**JORDAN VALLEY WATER CONSERVANCY DISTRICT
JA-2 FLOW CONTROL VAULT IMPROVEMENTS
DISTRICT PROJECT NO. 4352**

ADDENDUM NO. 2

SECTION VIEW A-A

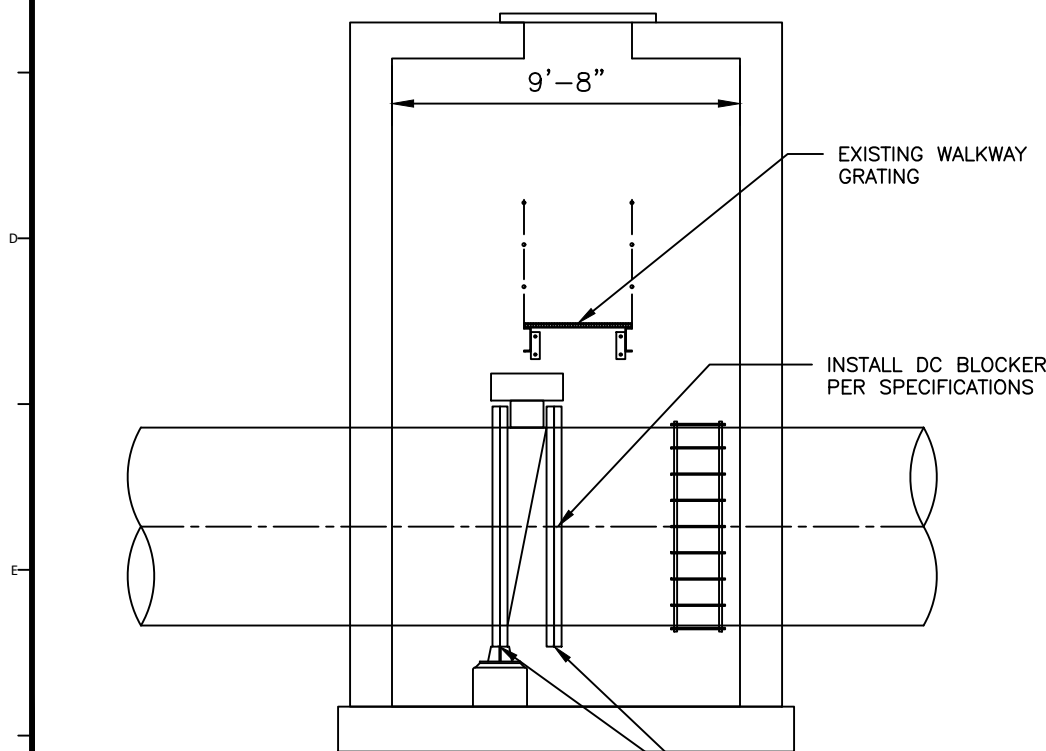
- 1.1.2 Drawing M3, two additional callouts were added to Section View A-A. One callout for installing insulating flange kits to both sides of the 66” butterfly valve and a cad welded jumper (2/0 awg copper wire) to be installed per specification listed below. The second callout is to include a DC Blocker on the middle flange pair, or the east set of flanges. Additionally, a detail for the DC Blocking Device Flange Mount has been added to the sheet.

DC BLOCKING DEVICE FLANGE MOUNT
NTS

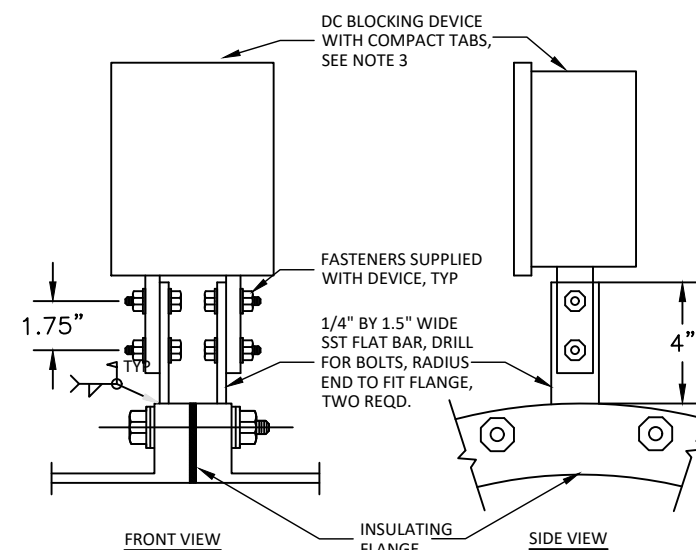
- 1.1.1 Drawing M1, item five (5) on the material schedule was revised to state “INSTALL INSULATING FLANGE AND DC BLOCKER AS SPECIFIED”. Along with this change item six (6) was added to the material schedule to state “INSTALL INSULATING FLANGE AS SPECIFIED”. Item five (5) will only be applied to the flanges connected to the dismantling joints adjacent to the meters. Please follow the additional specifications below and the “DC BLOCKING DEVICE FLANGE MOUNT” detail on the attached sheet M3.

- DO NOT COAT MOUNTING PLATES, FASTENERS, OR DEVICE TABS AFTER ASSEMBLY, CLEAN AND COAT WELD ONLY.
- NEGATIVE TAB OF DC BLOCKING DEVICE TO BE ON CATHODICALLY PROTECTED SIDE OF INSULATING FLANGE.
- COMPACT TABS ON BLOCKING DEVICE SHOWN FOR TOP MOUNTING, USE STANDARD TABS FOR MOUNTING AT PIPE SPRINGLINE.
